Technical Advisory Note

Project	Uniting Charlestown Modification 2	Project Number	SCT_00575
Client	TSA Management on behalf of Uniting		
Document Name	Traffic statement for Modification 2		
Version	2.0	Date	24 March 2026
Author	Shawn Cen	Principal Consultant	
Reviewer	Jonathan Busch	Director	
Authoriser	Jonathan Busch	Director

DRAWING TITLE
**FLOOR PLAN - LOWER
 GROUND**

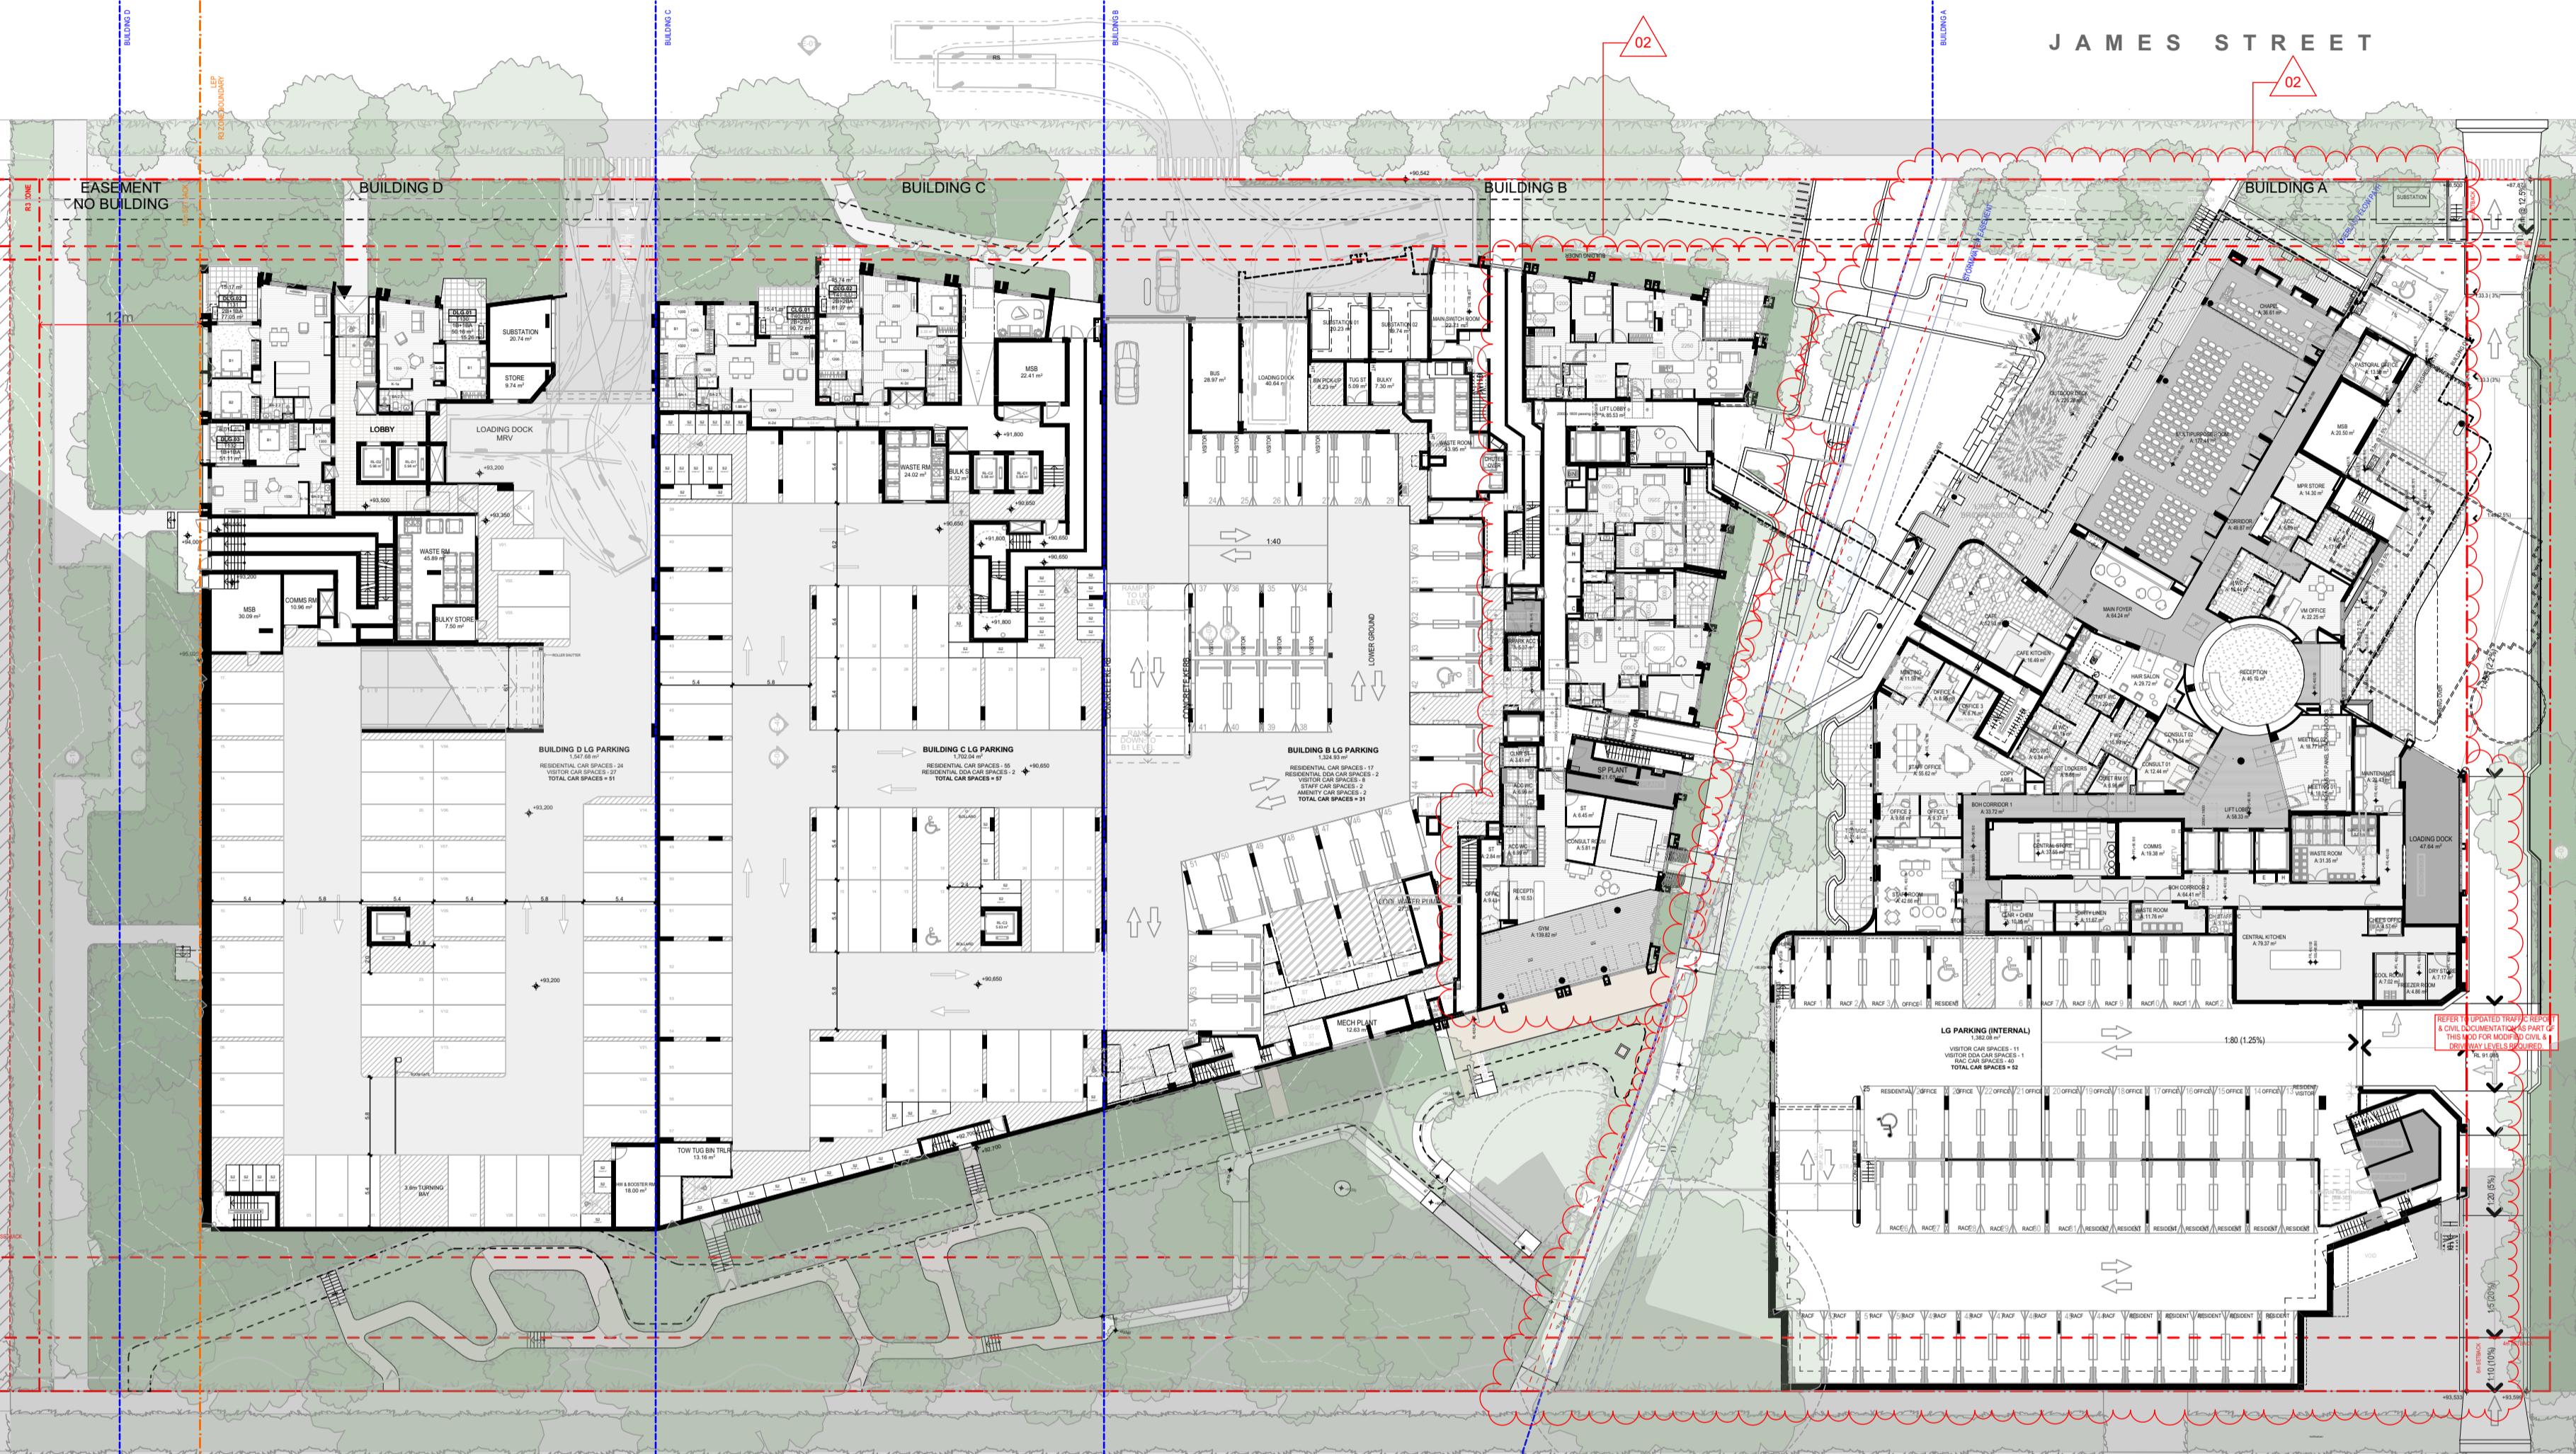
AS2890.1 section	Consistent	Comment
2.3.2 Parking angle	Yes	Angled parking spaces are provided as well as one reserved bay for an ambulance. The aisle is one-way northbound.

2.3.3 Parking aisle length	Yes	Parking aisles do not exceed 100 m in length.
2.4.1 Angle parking spaces	Yes	Minimum length 5.4 m of parking space satisfied as required. Minimum width 2.4 m satisfied as required for user classes 1A and 4.

2.4.2 Angle parking aisle	Yes	Minimum parking aisle width 5.8 m satisfied, with additional 300 mm where bounded by a wall.
2.4.3 Angle parking module layout	Yes	Angle parking module layouts are comparable to a typical layout.

2.4.5 Physical controls	TBC	The distance from the front of the parking space to the wheel stop at the point of contact to be 620 mm to 630 mm. This matter can be addressed in the detailed design.

2.4.5.5 Other protective devices	Not included in this review as this falls outside the expertise of traffic engineering.	
2.4.6 Gradients within parking modules	Yes	The maximum gradient parallel to the parking direction to be 1 in 20 (5%) and 1 in 16 (6.25%) in any other direction. Minimum gradient to be 1 in 200 (0.5%). The maximum gradient proposed within the parking area is 2.5%, which is compliant. Minimum gradient requirement is satisfied.

2.5.2 Layout design of circulation roadways and ramps	N/A	Unchanged under modification, already approved under the existing Development Application.
2.5.3 Circulation roadway and ramp grades	Yes	Straight ramps in the car parks are no longer than 20 m and not to exceed a maximum gradient of 1 in 4 (25%). 2m transitions are required at both ends 15% sag and 12.5% summit change of grade. The maximum gradient along the circulation roadway is 20% as proposed. Transitions are provided at a length of 2m of 12.5%.

3.2 Access driveways – width and location	Yes	Unchanged under modification, already approved under existing Development Application.
3.3 Gradients of access driveways	Performance solution	The grade of the access driveway (between road frontage and property line) is required to satisfy flood and drainage requirements, which contains: <ul style="list-style-type: none"> – 5.15% (between road frontage and footpath)+2.5% (across the footpath) at the entry – 5.3% (between road frontage and footpath)+2.5% (across the footpath) at the exit The slight exceeding of 5% requirement is considered minor due to the constraints of the site. Pedestrians would remain visible to drivers due to the minor difference from the prescribed gradient limit.

AS2890.1 section	Consistent	Comment
		A grade of 5% in the length of 6m has been provided when accessing the car parking area
3.4 Queueing areas	Yes	Unchanged under modification, already approved under the existing Development Application.

4.2 Bicycle parking	N/A	Bicycle parking is relocated to the landscape area between Building A and B, which will be addressed in later stages.
4.3 Signposting	TBC	Signposting to conform to requirements AS2890.1.

4.9 Humps	N/A	No humps are provided within either car park.
4.10 Special loading/unloading parking spaces	Yes	An ambulance space is to be provided within the external car park.

5.2 Column location and spacing	Yes	Minimum dimensions for locating columns are satisfied. Design envelope around a parked vehicle kept clear of columns and other obstructions.

5.3 Headroom	Yes	Minimum headroom clearance to be 2200 mm. Minimum clearance to be signposted. Headroom above shared spaces to be 2500 mm as required.
5.4 Design of enclosed garages	N/A	No enclosed garages are provided.

AS2890.6 section	Consistent	Comment
2.2 Location of accessible spaces	Yes	All accessible parking spaces are located within 50 m of an accessible entrance.

2.3.1 Shared area	Yes	All accessible parking spaces are provided with a rear and side shared area.
2.3.2 Side of vehicle	Yes	All accessible parking spaces are supplied with a shared area to the side of the space.

2.3.3 Rear of vehicle	TBC	Accessible parking spaces are supplied with sufficient rear shared areas within parking aisles as required. Parking aisles are to have a posted speed limit no greater than 10 km/hr, as can be addressed at subsequent stages.

2.4 Zone for bollard, post and columns	TBC	Shared spaces to the side of accessible parking spaces are to be supplied with a bollard, post, or column of minimum 1300 mm height as required. This matter can be addressed in detailed design.
		Luminance contrast not included in this review as this falls outside the expertise of traffic engineering.

2.5.1 Angled parking spaces	Yes	Accessible parking spaces are to be supplied with a shared space to the side of a minimum of 2400 mm wide x 5400 mm long. The space for adaptable housing has a dimension of 3.8m by 5.4m, which is considered compliant with AS4299.

2.5.2 Parallel parking spaces	N/A	No parallel parking spaces are provided within the car park.
2.6 Pavement slope and surface	TBC	Maximum gradient to be 1 in 40 (2.5%). This matter can be addressed in detailed design.
		Type of seal and slip resistance not included in this review as this falls outside the expertise of traffic engineering.

2.8 Kerb ramps	N/A	Kerb ramps are not provided or required.
3.1.1 Non residential space identification	TBC	Each accessible space shall be identified by means of a white symbol of access in accordance with AS 1428.1 between 800 mm and 1 000 mm high placed on a blue rectangle with no side more than 1 200 mm, and placed as a pavement marking in the centre of the space between 500 mm and 600 mm from its entry point. This matter can be addressed in detailed design.

3.1.2 Residential space identification	TBC	Residential accessible spaces are to be supplied with a bollard, post, or column in adjacent shared space. This matter can be addressed in detailed design.

3.2.1 Space delineation and shared marking		Not included in this review as this falls outside the expertise of traffic engineering.
3.2.2 Pavement markers for accessible spaces	TBC	Accessible parking spaces to be outlined with unbroken lines 80 mm to 100 mm on the long edge. This matter can be addressed in subsequent stages.

AS2890.6 section	Consistent	Comment
3.2.3 Pavement markers for shared areas	TBC	Shared areas to the side of accessible parking spaces are to be marked with unbroken lines 80 mm to 100 mm wide on all sides. Areas are also to be marked with diagonal stripes 150 mm to 200 mm wide with spaces 200 mm to 300 mm between stripes. Stripes are to be at an angle of 45 degrees to the side of the space.
3.2.4 Pavement markings		Not included in this review as this falls outside the expertise of traffic engineering.
